**FOR: City of Santa Fe – Guadalupe Street Reconstruction Project**

**ADDENDUM No. 2**  
**Guadalupe Street Reconstruction Project**  
Date of Issue: 11/18/2022

**GUADALUPE ST  
RECONSTRUCTION  
SANTA FE, NM  
CIP # 801B**

2-9

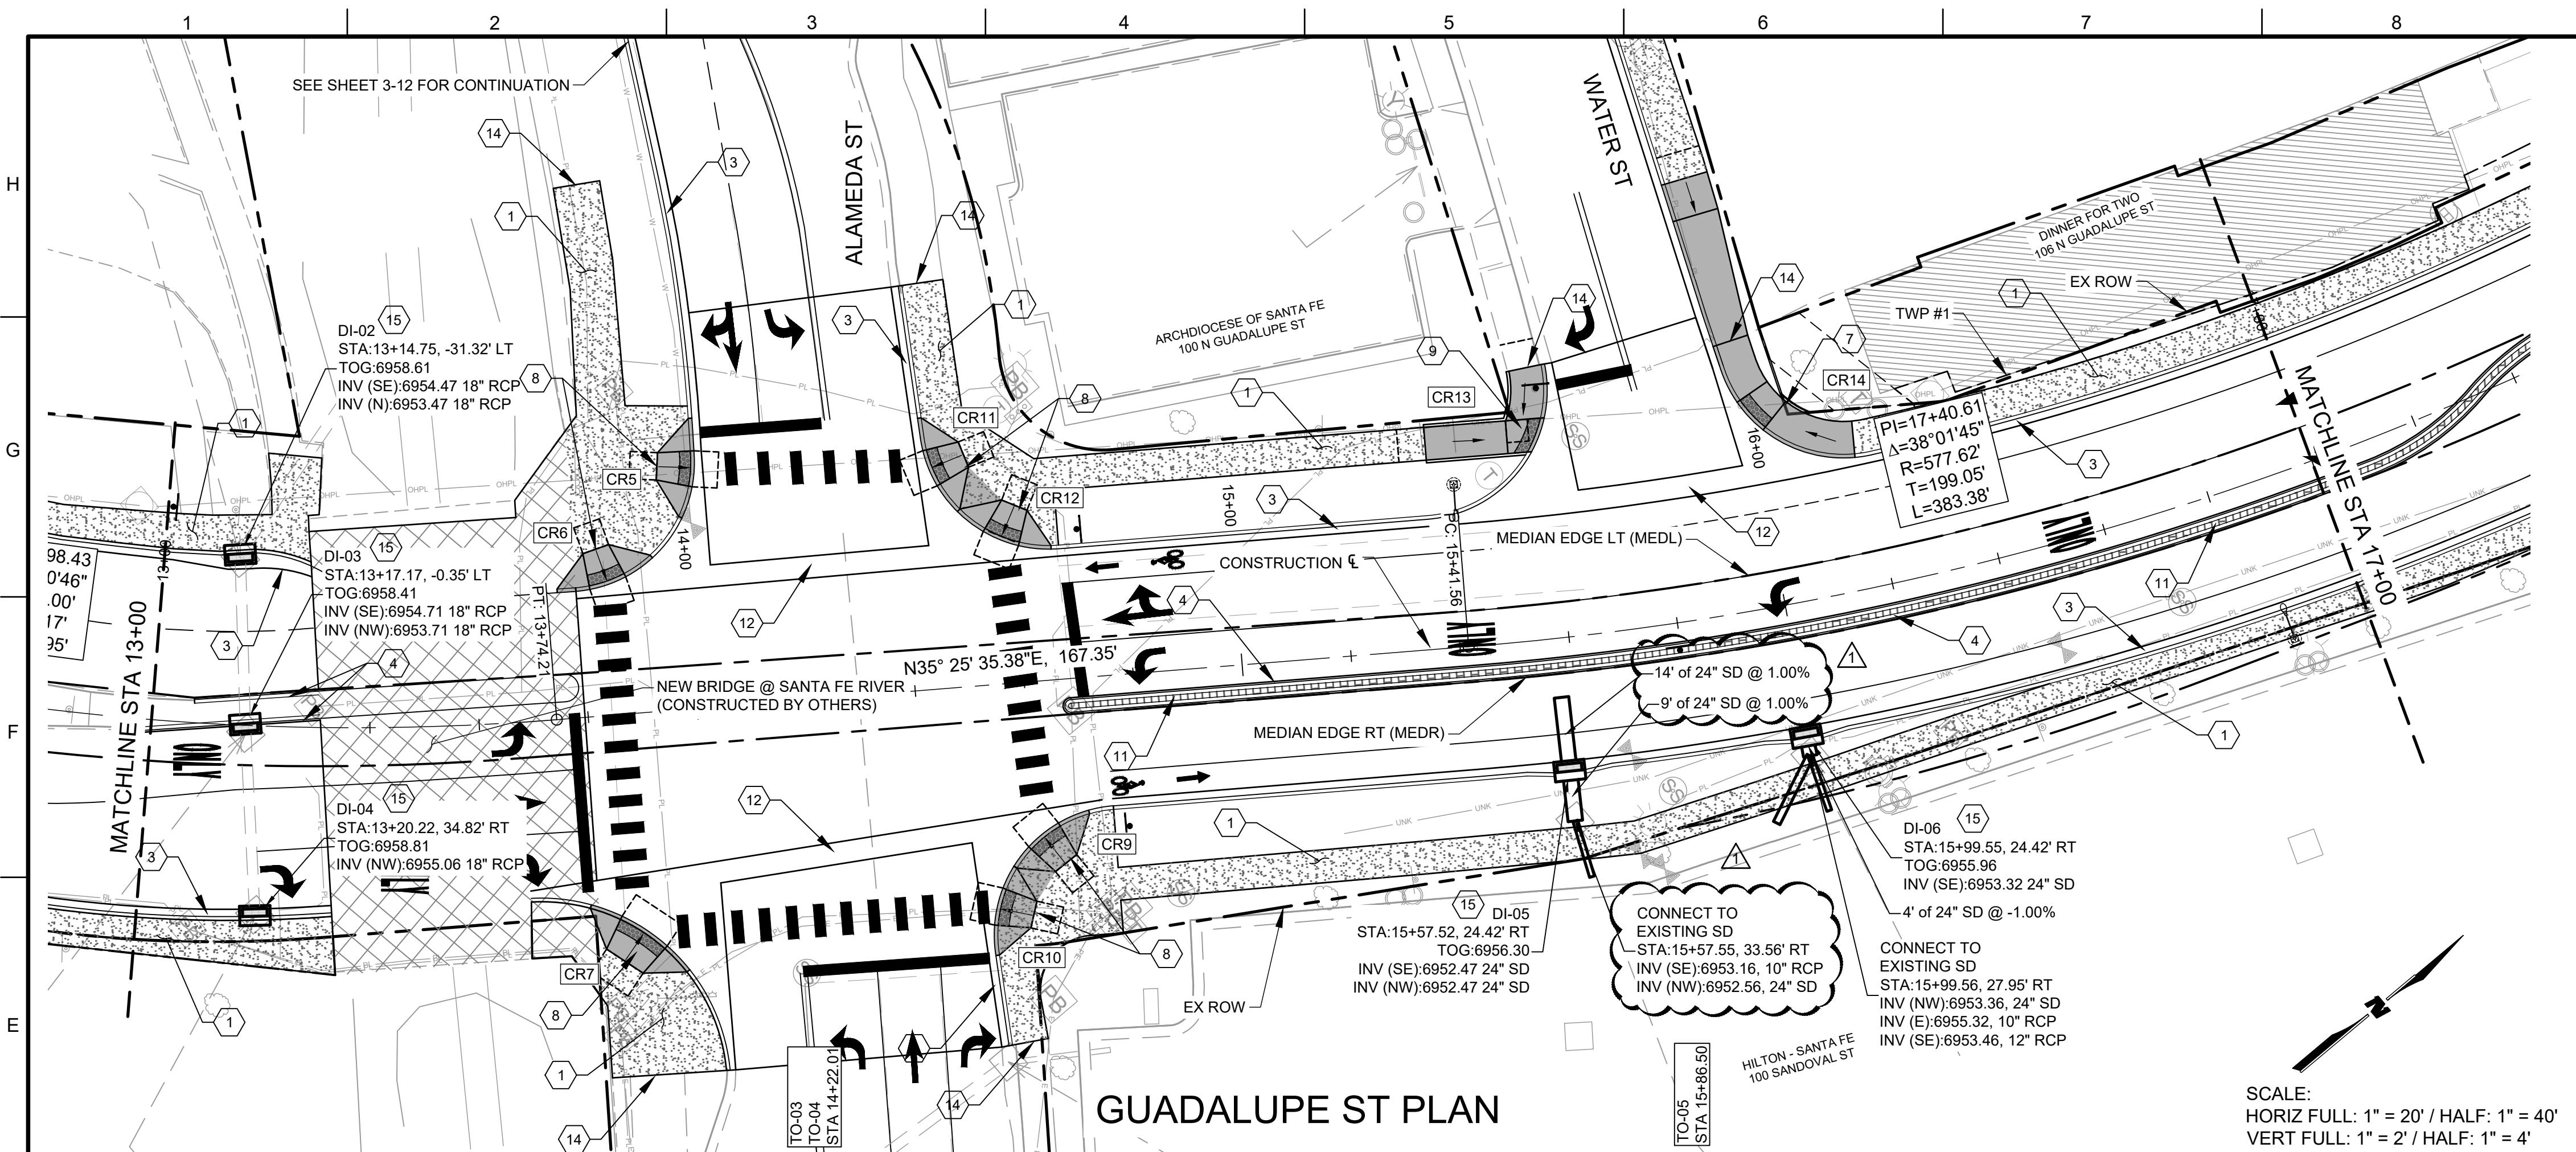
- a. *We have confirmed that the quantity of Bid Item 601110 is correct.*
4. Sheet 3-3 has two call outs for installing 22"x22" CBC related to DI-05 at station 15+57.52; however, it appears that there is not a bid item for this work. All structural concrete class A is indicated for signalization, and there is not a bid item for structural concrete class AA. Can a clarification be provided that states what Bid Item is to be used for payment related to the 22"x22" CBC, and if there is not a bid item can one be established?

- On Sheet 2-12, delete Item 663000 – Utility Allowance from schedule. See revised sheet 2-12.*

- a. *The installation of a 22"x22" CBC is not required. It will be 24" storm drain culvert per Bid Item 570437. It is not known where the centerline of the existing culvert pipe is located. It will be up to the contractor and project manager to identify location for construction. The Bid Form has been revised, see revised Bid Form. The concrete collar is included in the cost of Bid Item 570437. Sheets 2-9 and 3-3 have been revised, see attached.*

PROJECT NAME	WCI PROJECT NO:
	1760008500
	NMDOT PROJECT NO: S100460 & LP5008
DESIGNED BY:	TJA
DRAWN BY:	JEM
CHECKED BY:	TJA
DATE:	JUL 2022
SHEET TITLE	ROADWAY PLAN & PROFILE
SHEET NO:	3-7

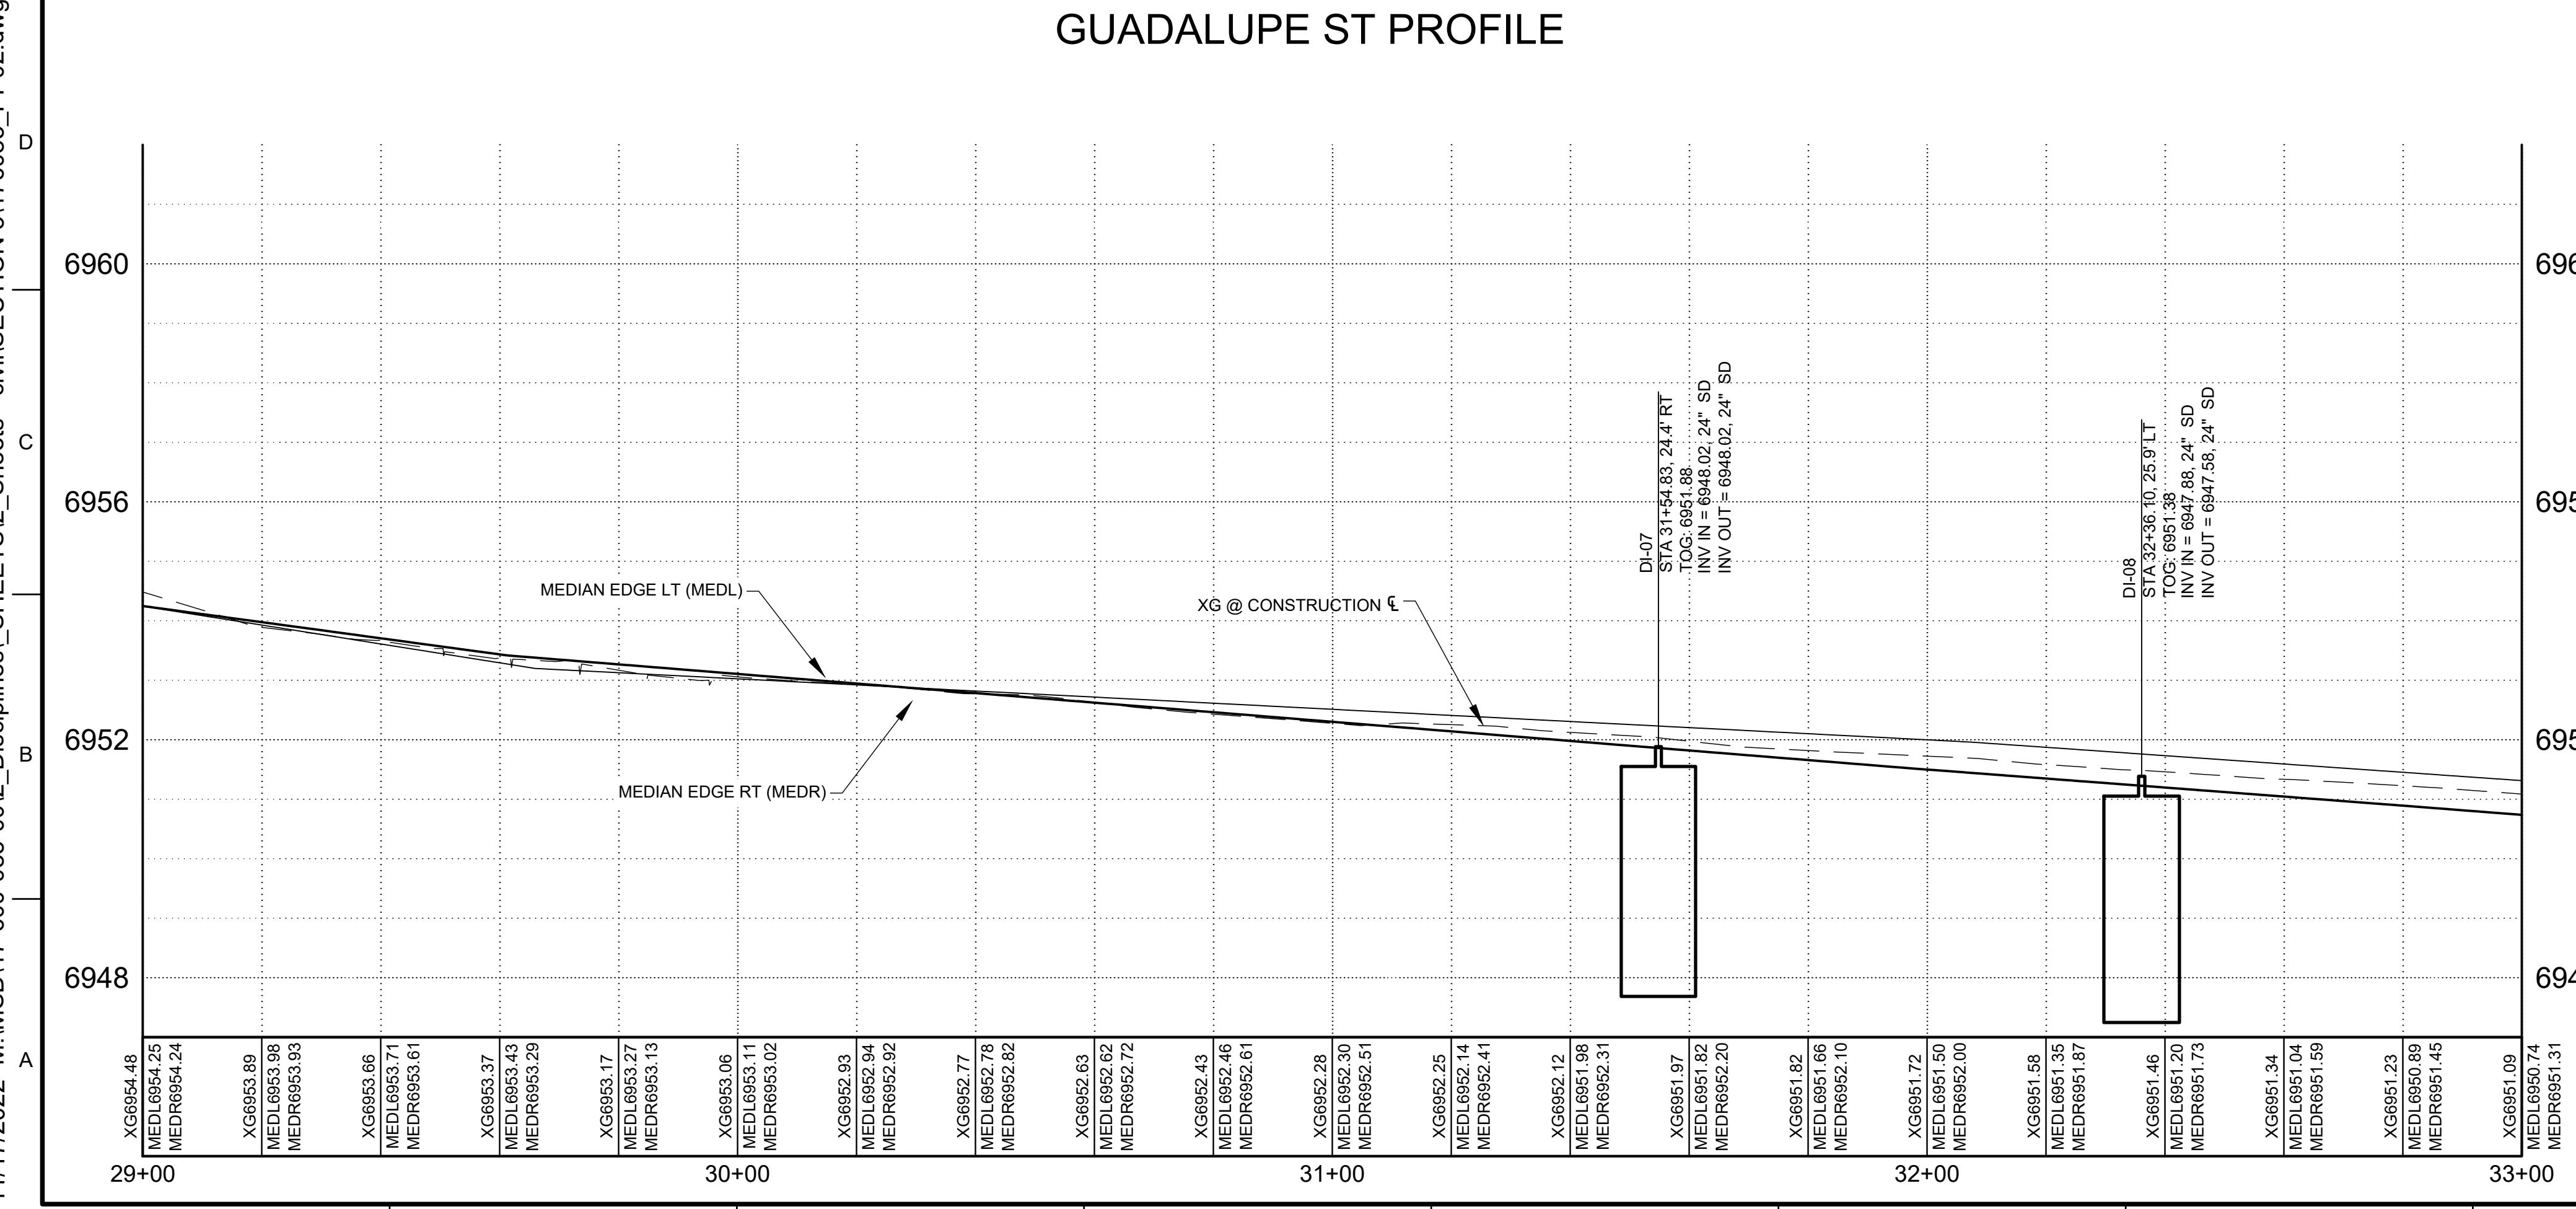
- a. *The header curb bid item will be established and paid per new Bid Item 609200. See revised Bid Form.*
7. Sheet 3-7 has a keyed note call out for 4" sidewalk for the section of sidewalk that runs through Jose St, and Sheet 3-6 does not have a call out indicating the type of sidewalk that runs through Park Ave. The Concrete Sidewalk 6" (Colored) schedule on sheet 2-10 indicates that the previously referenced sidewalk sections are 6" Colored sidewalk. Can it be confirmed that these two sections of sidewalk are to be constructed as 6" Colored Sidewalk?

- a. *Both areas shall be 6" concrete sidewalk per Bid Item 608006.*
8. The plans do not indicate that curb and gutter nor the valley gutters with fillets are to be colored, but it appears that the curb and gutter associated with ADA Ramps and Drive Pads are to be colored. Are all sections of curb and gutter and the valley gutters to be colored, and if not, are only the sections of curb and gutter adjacent to ADA ramps and drive pads to be colored?
